Board of Architectural Review

DATE: July 15, 2015
TO: Board of Architectural Review Chair and Members
THROUGH: Jason Sutphin, Community Development Division Chief JDS
FROM: Kelly O'Brien, AICP, BAR Liaison KO
SUBJECT: **Mosby Woods Pool House Renovation**

| 3. Request: | Proposed modifications to pool house facade |

MOSBY WOODS POOLHOUSE

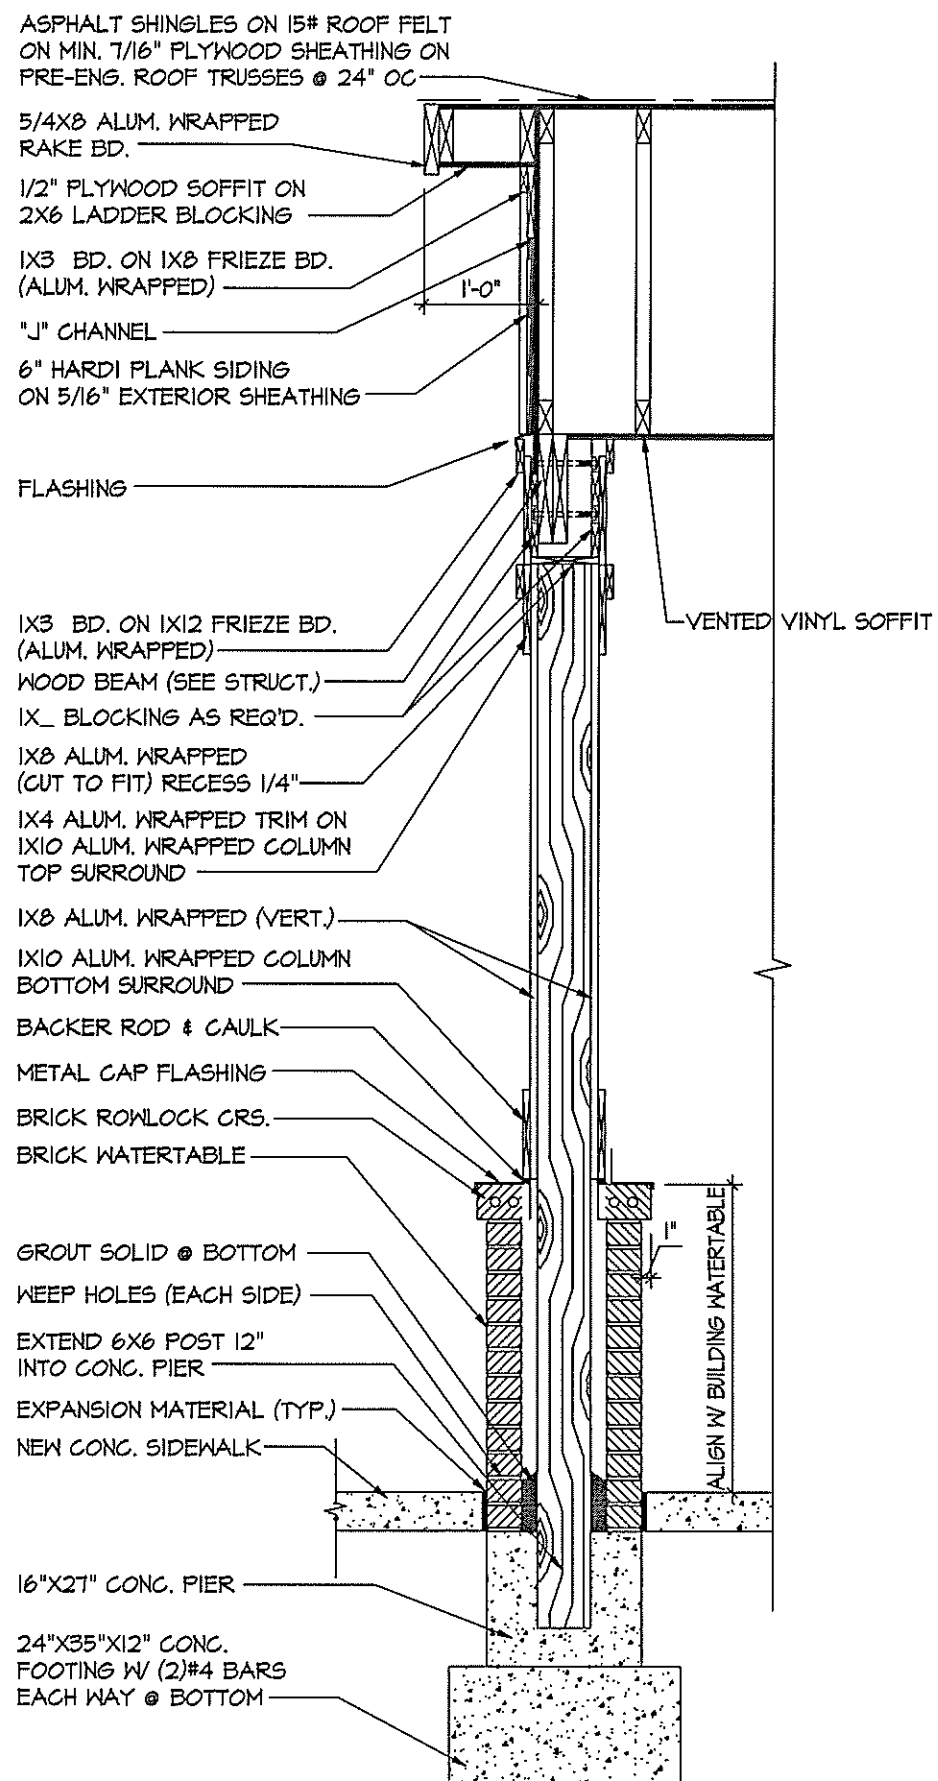
No specifications on manufacturer for the black metal fencing have been provided however staff has no issue with the design depicted in the renderings and would support approval of any fencing chosen that matches the rendering.

1. The proposed façade renovations and fencing shall be installed as shown on the plans received July 10, 2015 and rendered elevations received July 15, 2015, except as regulated by the Zoning Ordinance, and as may be modified by the Board of Architectural Review, the Director of Community Development and Planning, Zoning, or the Building Official.
